Subject: Arkansas Nuclear One - Units 1 and 2
Docket Nos. 50-313 and 50-368
License Nos. DPR-51 and NPP-6
IPEEE Supplemental RAI Response (TAC Nos. M83588 and M83589)

Supplemental RAI Responses Regarding IPEEE
Dated February 7, 2000 (0CNA020004)

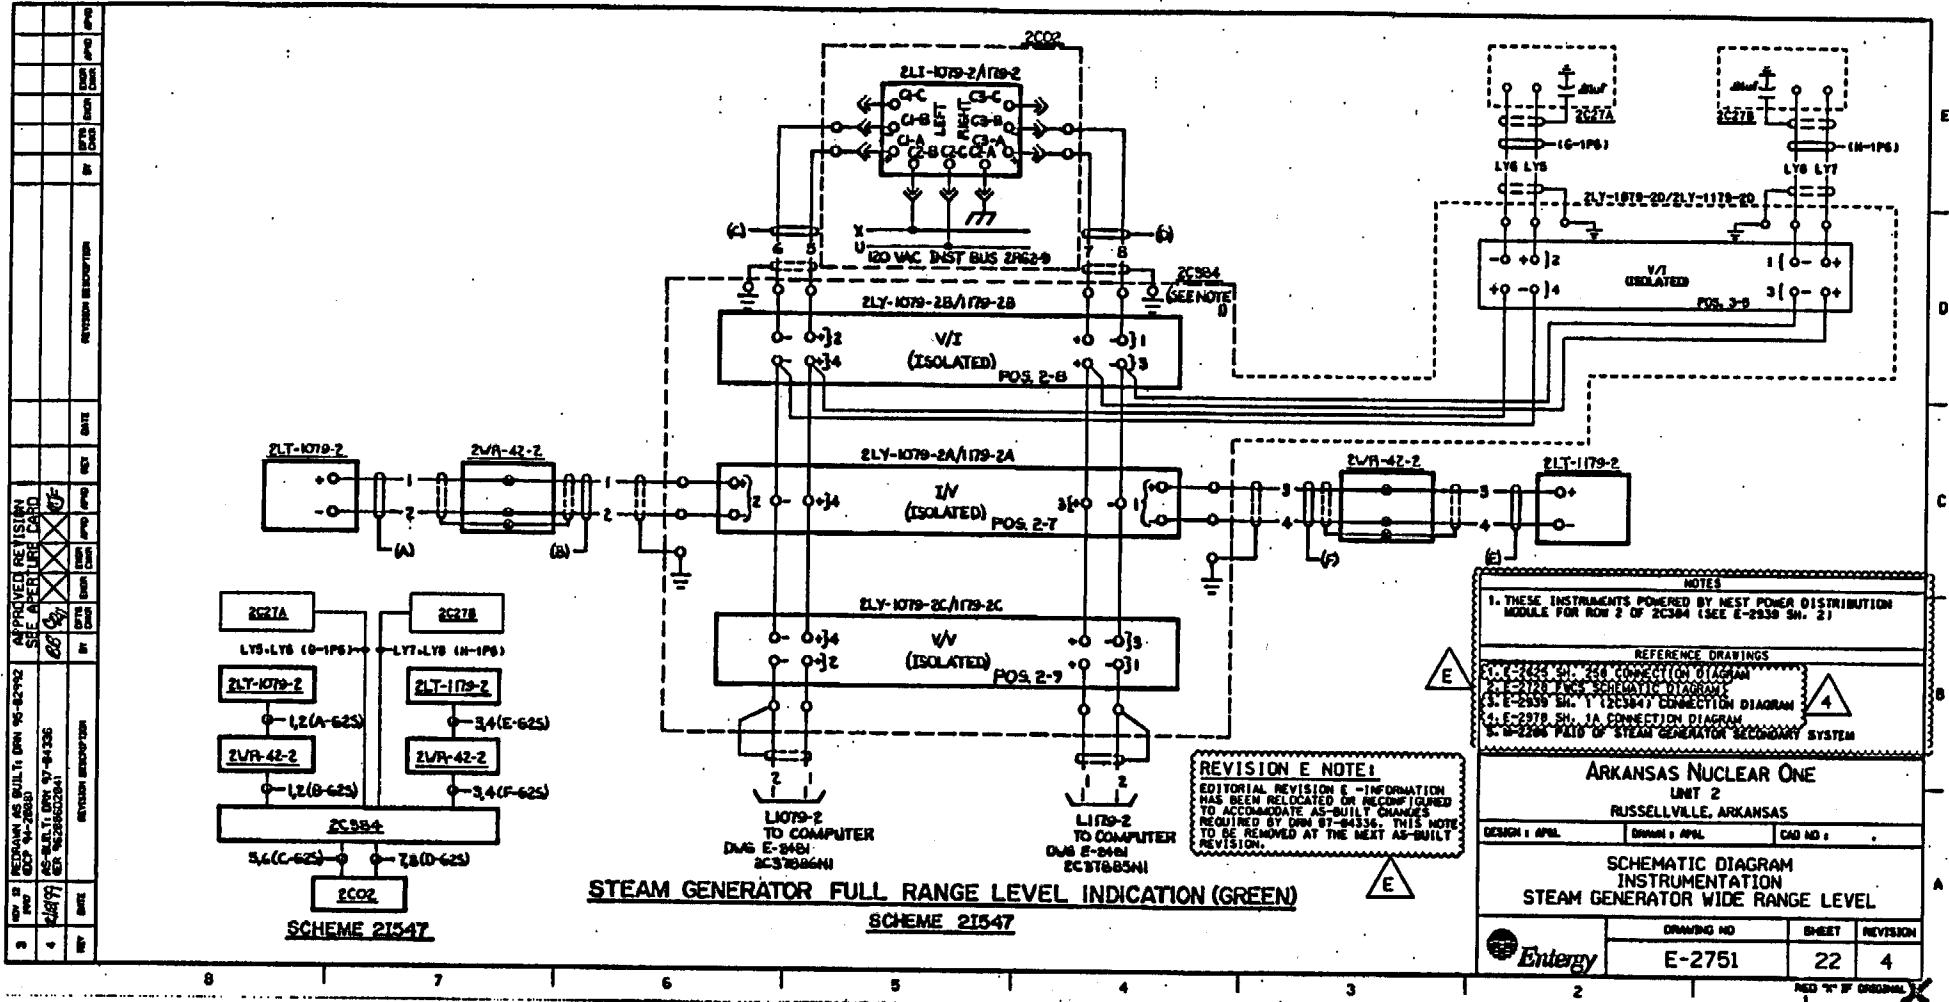
- a) Please provide a description and location of the signal conditioning circuitry that would be used to isolate control room circuits in the event of a fire-induced control room abandonment.

Electrical isolation is achieved by removing control power (i.e., opening the associated breakers) to the required safe shutdown components. Required instrumentation is monitored via the safety parameters display system (SPDS). Inputs to SPDS are isolated from the control room via appropriate signal conditioning devices. A description of the SPDS and the associated isolation devices was previously submitted on July 1, 1982 (refer to Appendix A of the submittal), and subsequently approved by an SER dated May 13, 1983. A typical example of the instrumentation schematic is attached.
